**Display**

Subject: **EXTENSION OF WHITE BALANCE  
 ADJUSTMENT RANGE**

Model: **BVM-1310/1311/1315/1316/1316C/1910  
 BVM-1911/1912/1915/1916**

**Figure 1**

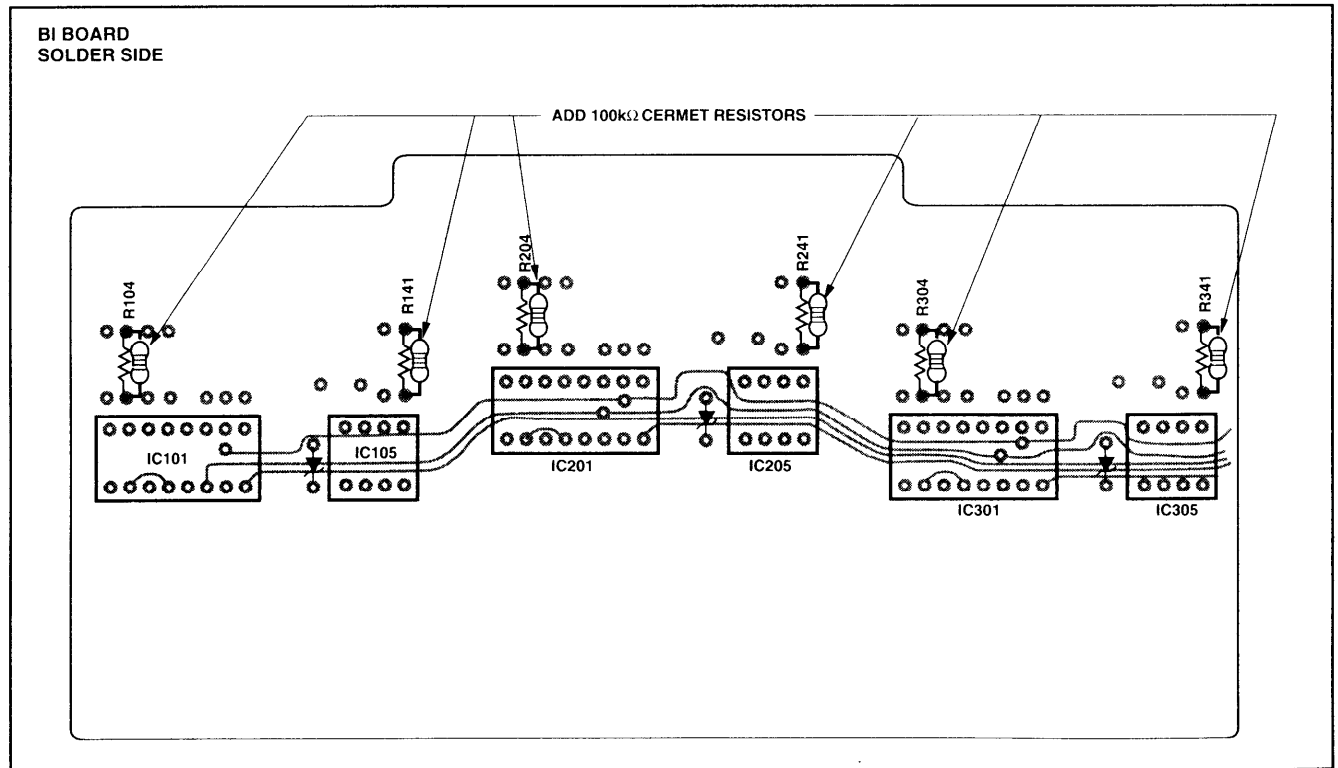
Due to slight variations among CRTs, the temperature of a desired color may exceed the white balance adjustment range. In such cases, the adjustment range can be extended by performing the following modification procedure.

**BI Board, Solder Side  
 (See Figures 1 and 2.)**

1. Add a 100kΩ cermet resistor in parallel to each of the following: R104, R141, R204, R241, R304, R341.
2. Verify that color temperature can be properly adjusted.

Part No.	Description	Qty.
1-215-469-00	Res, Cermet, 100kΩ, 1%, 1/4W	6
